Commission Agenda Report

Planning Commission
Special Meeting
01-11-22
Item 1.B.

Subject: Malibu Inn Motel - Coastal Development Permit No. 09-067, Mitigated Negative Declaration No. 20-003 and Initial Study No. 20-003, Conditional Use Permit No. 18-002, Variance Nos. 18-029, 18-030, 18-031, and 20-035, Site Plan Review No. 18-025, and Joint Use Parking Agreement No. 18-001 – An application for development of a motel project (Continued from December 6, 2021)

Location: 22959 Pacific Coast Highway, within the appealable coastal zone
APN: 4452-019-005
Owner: Surfrider Plaza, LLC

Figure 3 – Representative Cross Section

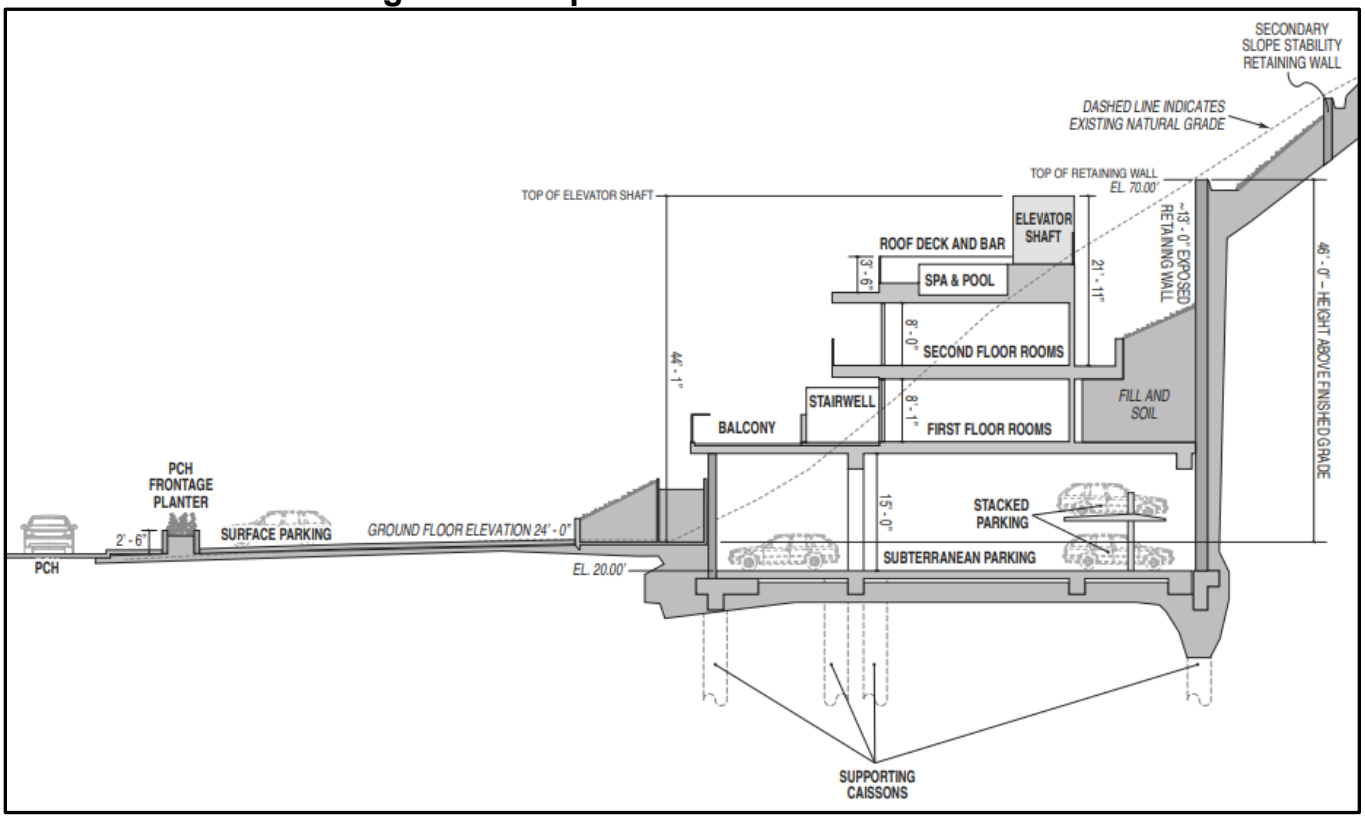
My first point of opposition is that there is no relief in our LIP for a retaining wall that is fifty feet tall (the dimensioning of their figure 3 is incorrect), with thirteen feet exposed, and a secondary retaining wall behind it.

Although described as subterranean parking, to say the parking structure is subterranean is misleading since only about 4 ft is actually underground. This parking structure is not subterranean since the majority of the parking is above ground level. (See figure 3 ND.)

The comment notes that the proposed retaining wall could impact the visual character of the area, although the wall would not be visible to passersby on PCH. The comment incorrectly states Figure 3 is inaccurate in regards to Figure 3's retaining wall height. As described in Section 1.3, *Project Description*, of the IS-MND, the back support wall would be a height of 46 feet above finished grade and approximately 52.5 feet above the finished floor elevation of the subterranean parking level. Therefore, Figure 3 is accurate in its depiction of the retaining wall. Further, a variance would be required for the proposed installation of a retaining wall taller than 6 feet and on a slope steeper than 2.5 (horizontal) to 1 (vertical) slopes.

SHEET P.1

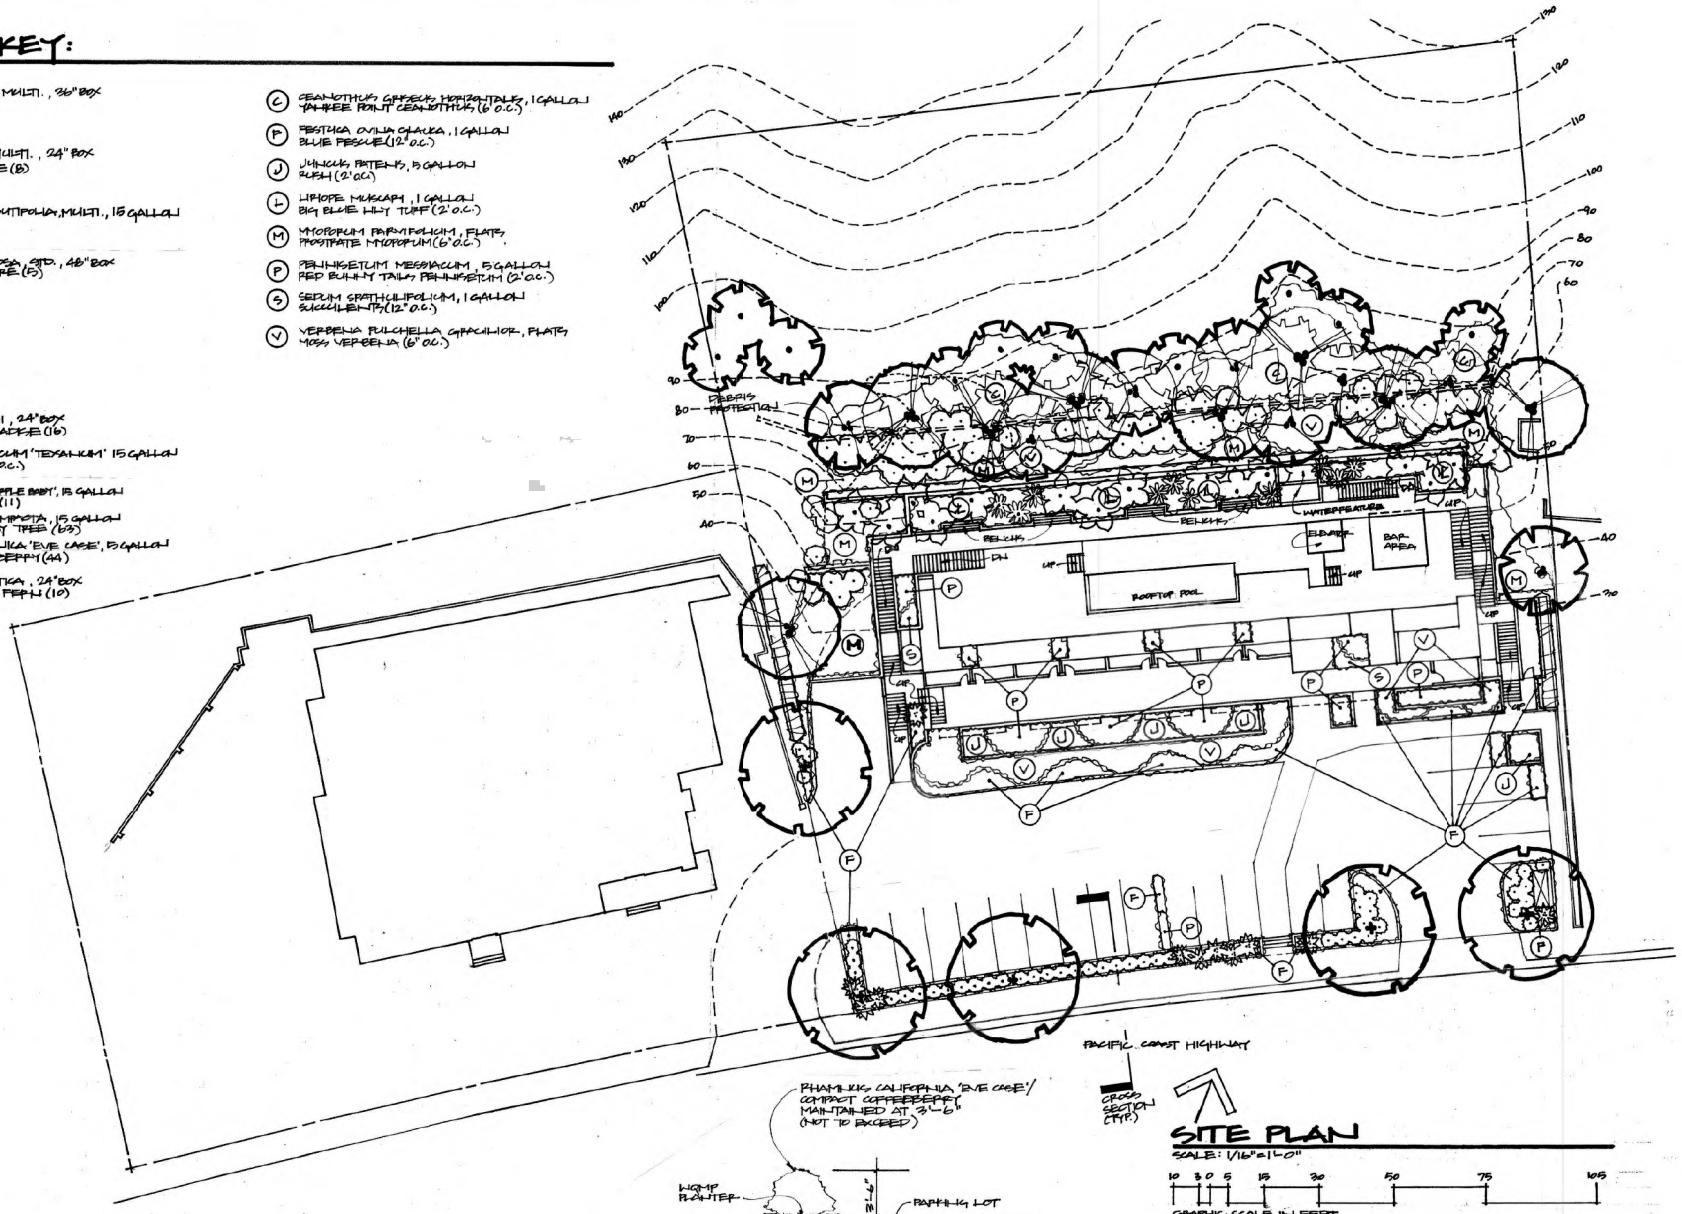
1. It is recommended that the landscaping plan be revised to replace the proposed California Sycamore tree at the southwest corner of the subject property with a tree that is less prone to damage the surrounding sidewalk and parking lot such a Toyon (*Heteromeles arbutifolia*).

The owner has chosen to keep the California Sycamore trees in an 18-inch root barrier encircling the root ball to minimize potential root damage to the sidewalk or parking lot area. The owner is concerned that the suggested Toyon trees are smaller trees and their canopy would interfere with parking and small berries would be a nuisance. A condition of approval has been added requiring that the landscaping plan be revised to include a detail

of the barrier encircling root balls and that the California Sycamore trees be installed in compliance with the detail.

Figure 3 – Representative Cross Section

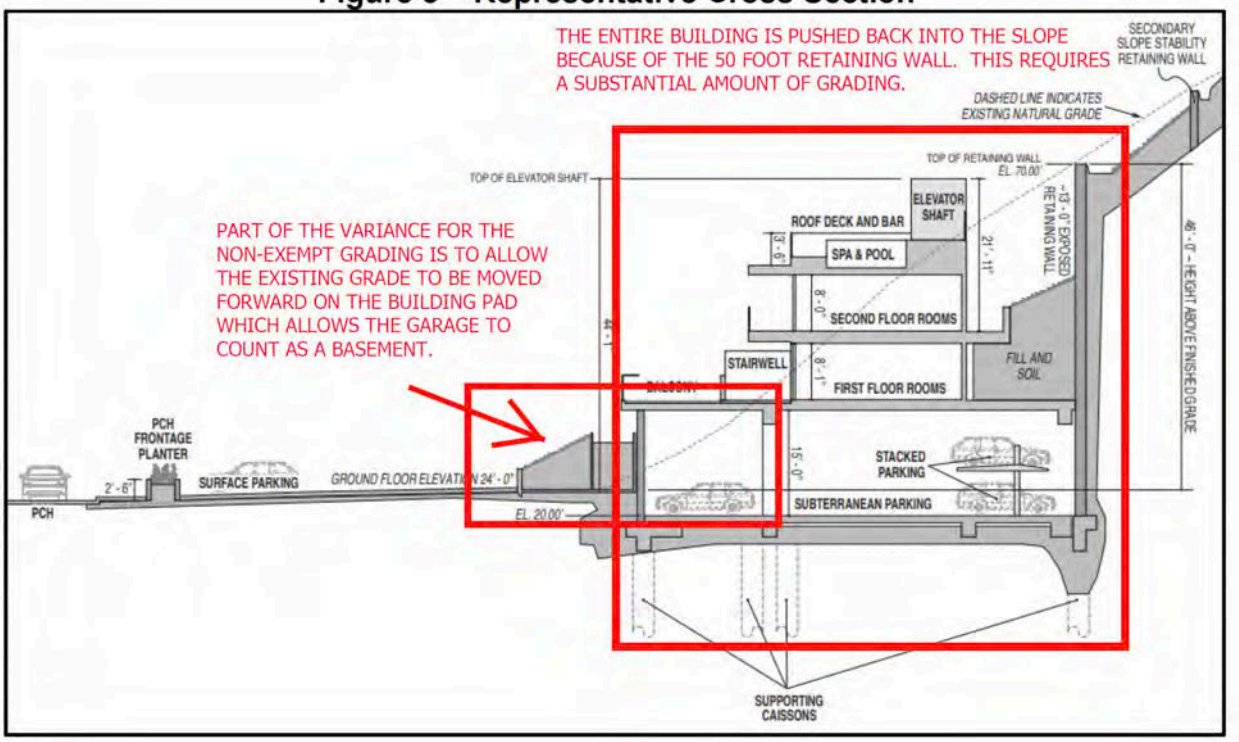
8.1 My first point of opposition is that there is no relief in our LIP for a retaining wall that is fifty feet tall (the dimensioning of their figure 3 is incorrect), with thirteen feet exposed, and a secondary retaining wall behind it.

18.13 **Although described as subterranean parking, to say the parking structure is subterranean is misleading since only about 4 ft is actually underground. This parking structure is not subterranean since the majority of the parking is above ground level. (See figure 3 ND.)**
